24.008 CR 747
rev -
Current version:
5.6.0

Title:	Introduction of USIM in the figure "Overview mobility management protocol"		
Source:	Siemens AG		
Work item code:	TEI5	Date:	19/02/2003
Category:	F Use <u>one</u> of the following categories: F (correction) A (corresponds to a correction in an earlier release) B (addition of feature), C (functional modification of feature) D (editorial modification) Detailed explanations of the above categories can be found in 3GPP TR 21.900 .		Release: Rel-5 Use <u>one</u> of the following releases: 2 (GSM Phase 2) R96 (Release 1996) R97 (Release 1997) R98 (Release 1998) R99 (Release 1999) Rel-4 (Release 4) Rel-5 (Release 5) Rel-6 (Release 6)

Figure 4.1a/3GPP TS 24.008: Overview mobility management protocol/MS Side

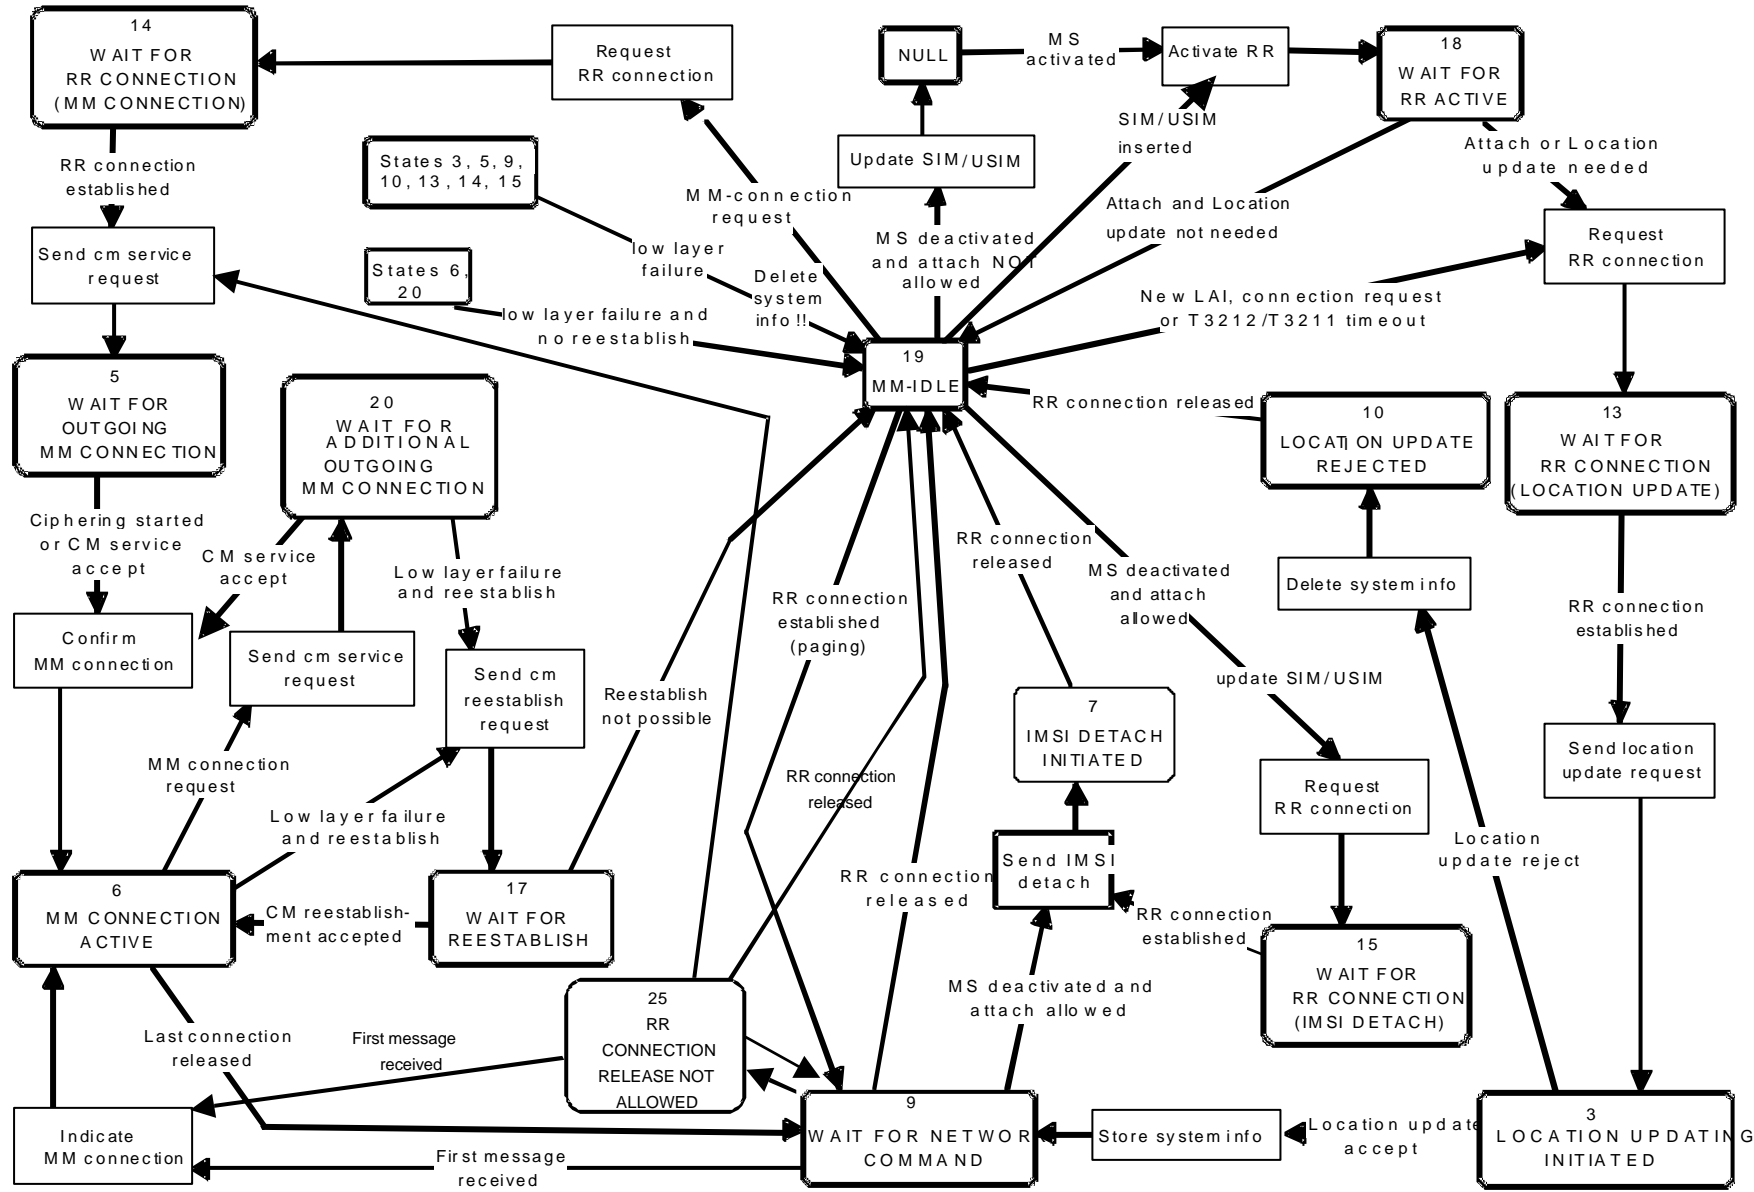
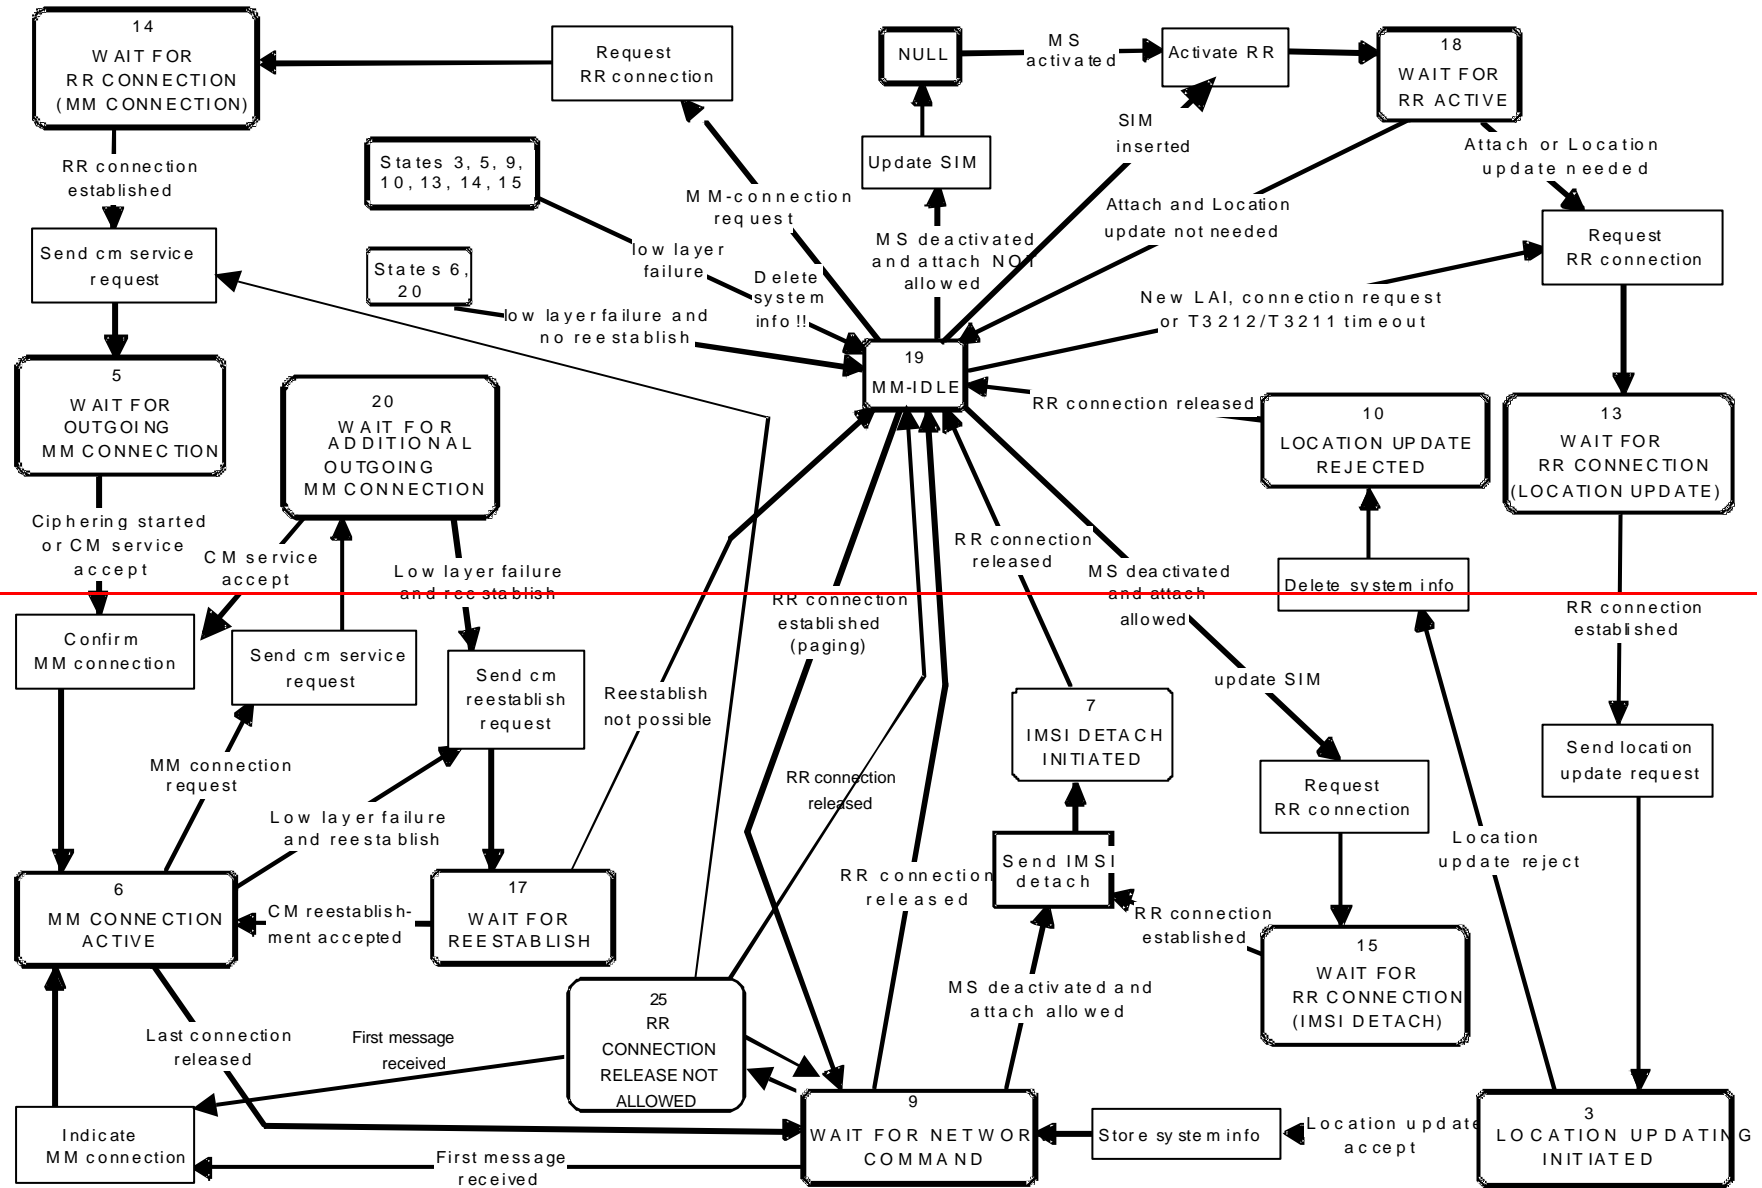
Reason for change:	With CR 24.008-731rev1 in Tdoc NP-030055 (N1-030213) the discrimination between SIM and USIM is introduced into 24.008, however, figure 4.1a was not updated accordingly.
Summary of change:	"SIM" is replaced by "SIM/USIM" in three places in figure 4.1a.
Consequences if not approved:	Inconsistent specification.
